General Comments

C: The study by Li et al. aims at presenting a method that allows the automated mapping of glacier extents in a challenging region using Google Earth Engine at high temporal resolution, up to annually from Sentinel-2. They used the results to consider area changes when calculating glacier mass balance. If the mapping had worked, this would have been an important study to improve related results also for other regions in the world. Unfortunately, the outcome of the mapping is not useful for any assessment. In this regard I want to acknowledge that the authors have provided the results of their mapping effort in the supplemental material. Without this, my evaluation would have been different as the paper is otherwise well written and the idea to just use all data available and combine it for the best possible result is fine. However, the largely arbitrary area changes from dataset to dataset (for individual glaciers partly larger than 50% from year to year) are obvious and glaciologically impossible. The authors mention that there are the usual problems with debris cover, clouds and shadow, but they have seemingly not recognized how large and arbitrary the variabili

Fig1 Updated data on area changes

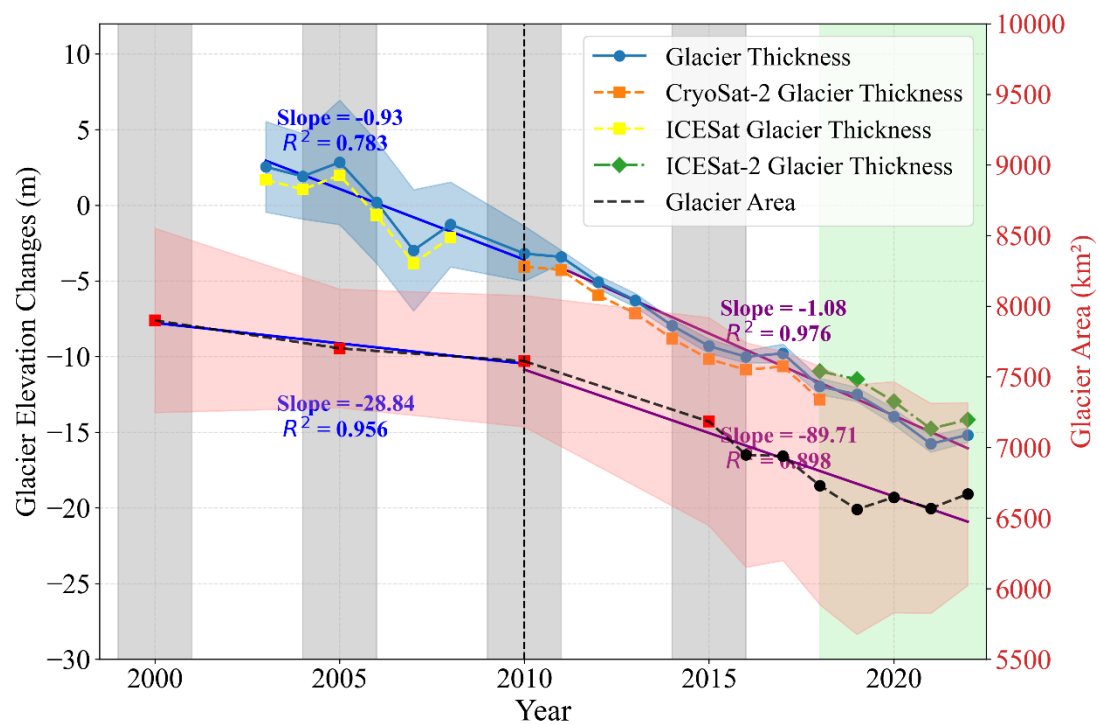
C: Neither the unrealistic area increase by about 500 km² (estimated from Fig. 8, numbers for individual years are not provided) from 2019 to 2022 (naming it as a ‘consistent decline’ in L387), nor the sudden strong increase from 2016 to 2017 is discussed or considered as unrealistic. Instead, the authors correlate glacier elevation changes (wrongly labelled as ‘Glacier Thickness’ in Fig. 8) with glacier area changes as they assume there is a correlation (L407) and think that the correlation can be used as a validation (L413) of their (wrong) glacier areas. In fact, area changes are mostly driven by the ice thickness distribution along the glacier perimeter (thus depending on the shape of the glacier cross-profile) and are a longer-term response to changes in flow dynamics (glaciers have a response time). Hence, also the follow on analysis is a bit strange. In this regard, it is also unclear to me why the authors rely on results from Cryosat and ICESat (with their diverse range of issues) for such small glaciers instead of the Hugonnet et al. (2021) dataset that is widely used? As this dataset is not even mentioned in the comparison Table 1, I wonder why. Is the dataset too bad in quality?

R: We appreciate your suggestions. We acknowledge that the initial glacier extent results showed unrealistic year-to-year variability. To address this, we re-examined the classification outputs on a glacier-by-glacier basis and applied post-processing to flag and remove implausible area changes, including abrupt fluctuations or geometrically inconsistent outlines. Invalid outlines were replaced with the closest temporally consistent results. After these adjustments, the overall mapping is more stable, although uncertainties remain, particularly for complex glaciers. Glacier-by-glacier quality control was applied to detect and correct implausible changes, replacing them with temporally consistent outlines where possible, and marking unreliable years as no-data. Figures and analyses have been updated, and the Discussion now explicitly addresses these anomalies and their underlying causes. Regarding Fig. 8, we corrected the label from “Glacier Thickness” to “Glacier Elevation Change.” We also removed any

suggestion that the observed correlation between glacier elevation change and area change constitutes a form of validation, as glacier area and elevation changes are not necessarily synchronous or directly correlated per you suggest. For Hugonnet et al. (2021) dataset, a direct comparison with their study was not conducted initially. This is because we wanted to compare them with the results of time series of glacier mass balance, rather than trends. According to your suggestion, we have included the Hugonnet et al. (2021) dataset for comparison.

Fig2 Updates to figure 7

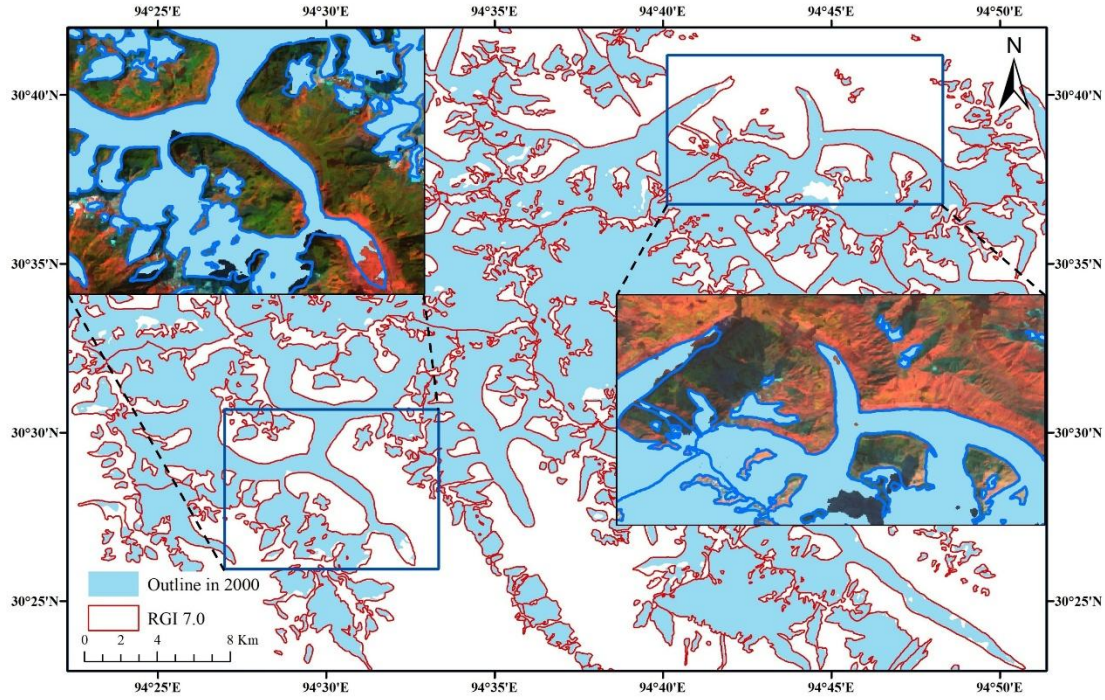
C: I see missing debris-covered glacier parts and that large regions in shadow are sometimes missing. Hence, intensive manual editing would be required before resulting outlines could be used for change assessment. The statement that glaciers ‘are well identified’ (L377) seems misleading in this regard. Although the year 2000 dataset is likely the most complete regarding shadow and debris mapping, showing a region where the method does not work and discussing it would have been more helpful. One can see the problems of the classification a little bit for the 2022 outlines of the right glacier in the upper left panel [please name them properly a), b) and c)] of Fig. 8, but the image is very dark (what about some contrast stretching?), the lines are hard to see (also the red outlines on a reddish background in the insets of Fig. 7 are barely visible) and the wrong mapping results are not really discussed.

R: We are grateful for your comment. We acknowledge the limitations of our approach, as accurately identifying debris-covered glaciers remains a major challenging. As noted in our previous response, the spectral characteristics of debris-covered glaciers complicate their discrimination, and our sample selection strategy significantly influenced the results. For the year 2000, we relied on the RGI 7.0 for training sample delineation, which helped achieve relatively high mapping accuracy for debris-covered glaciers. In subsequent years, however, we intentionally avoided using the RGI to account for glacier retreat, but our limited experience in manual sample selection led to insufficient representation of debris-covered ice, resulting in notable omissions and inconsistent delineation over time. This explains the substantial variability observed in debris-covered glacier extents between different periods. Good train dataset is vital in our approach.

We also recognize that the original figure suffered from low contrast, making some

lines difficult to discern, particularly the red outlines on reddish backgrounds in the insets of Fig. 7. In the revised manuscript, we applied contrast stretching and adjusted the color schemes to improve visibility. Additionally, the discussion on mapping inaccuracies has been expanded to clarify the sources of misclassification and their potential impacts on the results.

Fig3 Updates to figure 4

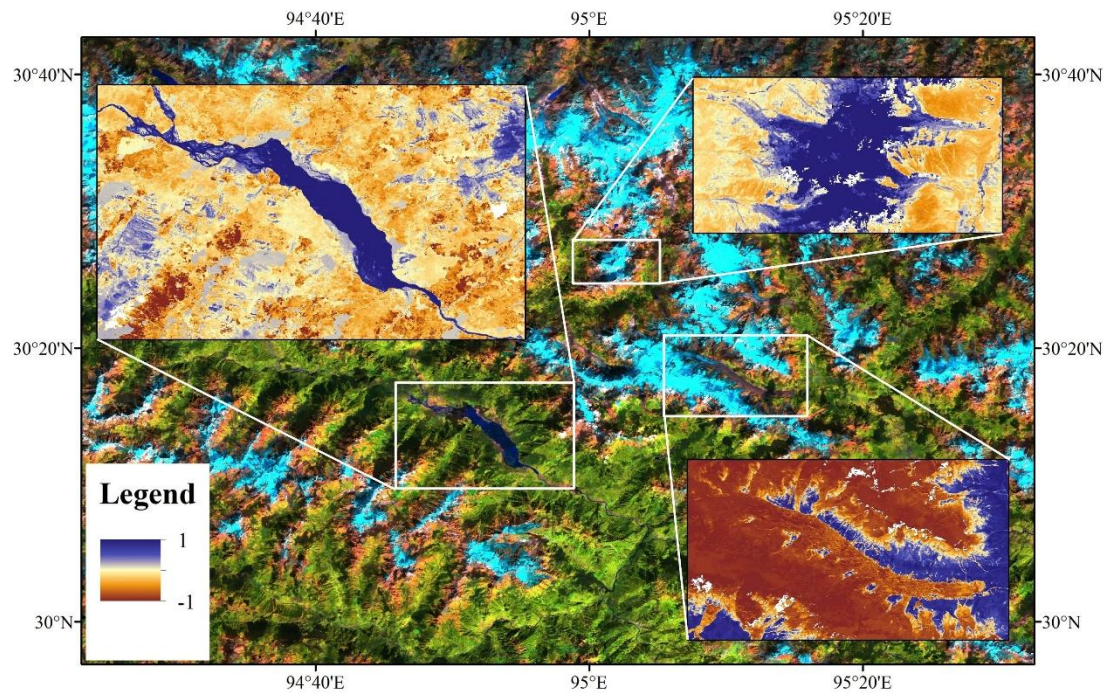
C: L261: Figure 4: The blue and red lines and squares are difficult to see against the dark background. Also the annotations and legends of the insets are partly hard to see. It needs also to be explained what is what. Just writing in the text that types can be clearly distinguished is a bit thin. The same applies to all panels in Fig. 5. The panels are too small, the legends are unreadable and it is unclear what is what.

R: We appreciate your suggestion. We have enhanced the visibility of Figures 4 and 5 by adjusting line and marker colors to higher-contrast shades, enlarging the panels, and ensuring that all legends and annotations are clearly readable. The captions and main text have also been revised to explicitly explain the meaning of each line, marker, and panel, making the figures fully interpretable independently of the text.

Fig 4 example3

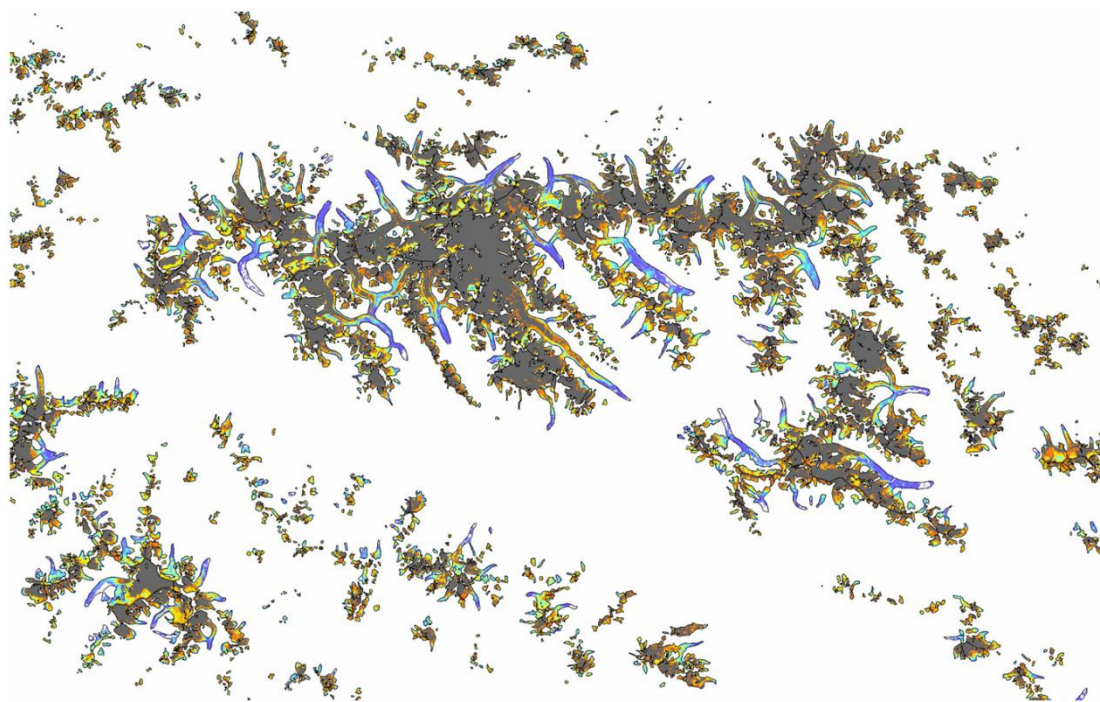
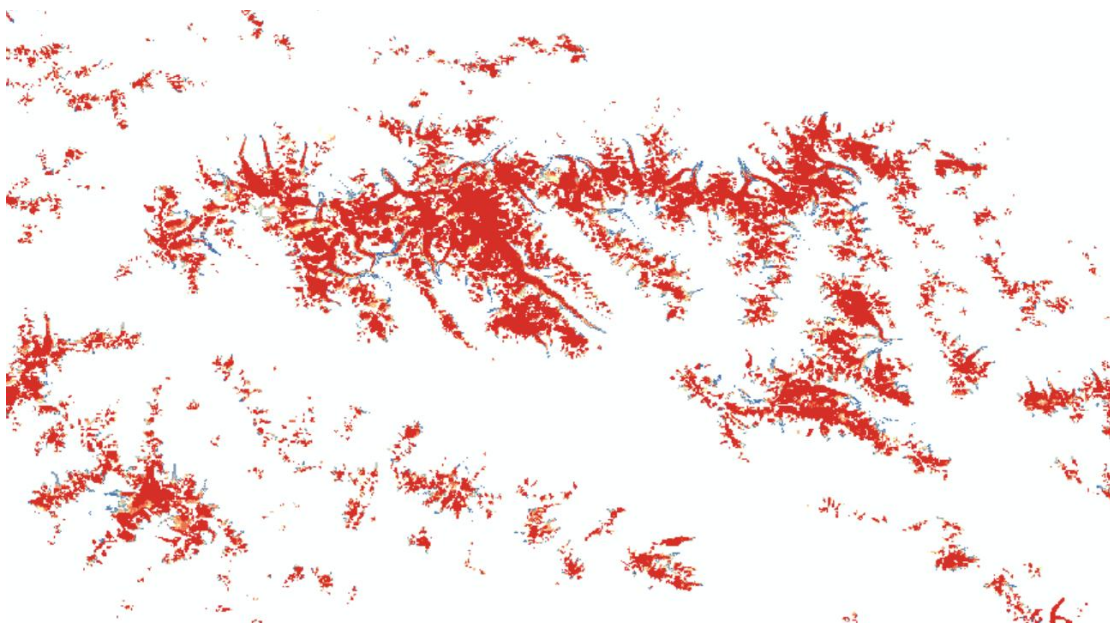
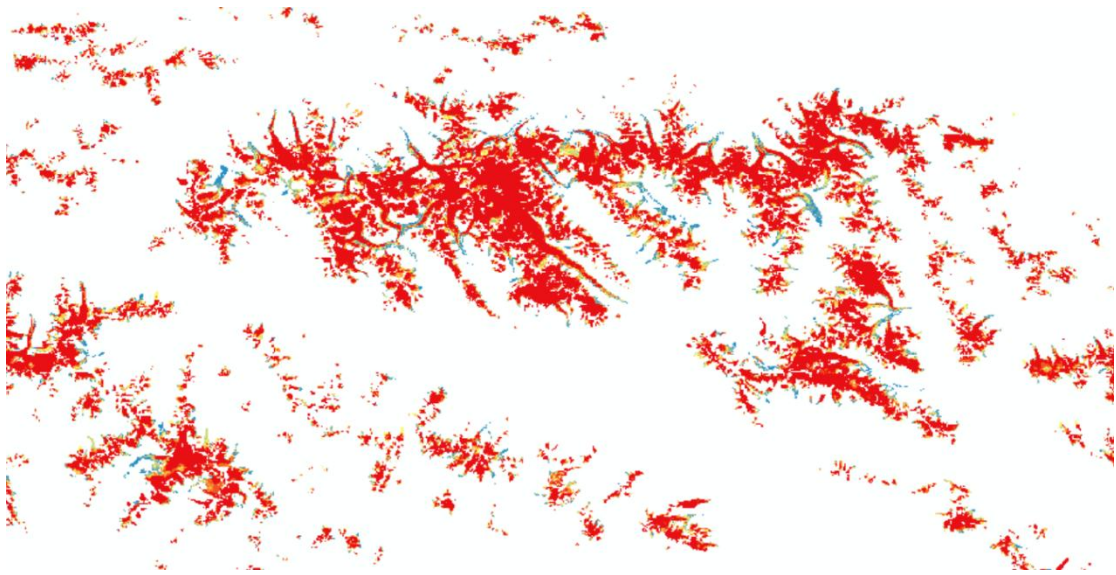
C: A final major point of concern is the general set-up of the study. First, the elevation change datasets are introduced in the Discussion Section 5.2 rather than in Sections 2.2 and 3. Their description is thus very short and the processing method unclear (e.g. how has the radar penetration into snow been corrected?). This can likely easily be adjusted. The motivation to determine annual area changes is mentioned, but not critically discussed. Even when the resulting glacier outlines would have been correct, a one-pixel (two pixels for debris-covered regions) uncertainty at 30 m resolution relates to a 30 and 60 m location uncertainty of the outline. With an assumed annual terminus retreat of 5 to 10 m / year (much less around the perimeter), one has to wait several years before new outlines make sense compared to uncertainties. But here the mapped termini could be wrong by several km, so change assessment is not an option. To make my major objection of the high variability in the mapping results clearer, I have added

all glacier maps (setting the no data value to 0 before) and received a very colourful picture. On the last two pages of this review, I show a few examples for illustration. If the mapping had been correct, colours should only appear near the terminus and around the perimeter. As a note, this is just the result of a simple adding without a timeline, not revealing the partly strong year-to-year jumps in mapped glacier areas.

C: L471: As far as I can see it, most gaps are due to not mapping debris-covered glacier parts.

R: We appreciate your suggestion. For the frequency maps generated from our preliminary updated data, including the 2000 dataset greatly exaggerates apparent glacier retreat. This occurs because the 2000 classification samples were manually delineated based on the RGI dataset, enabling relatively accurate mapping of debris-covered glaciers. For subsequent years, limited experience in distinguishing debris-covered glaciers resulted in samples that are less reliable, causing the classification to miss a substantial portion of these glaciers.

Following the demo area you provided, we show the results of the initial modifications to the area:
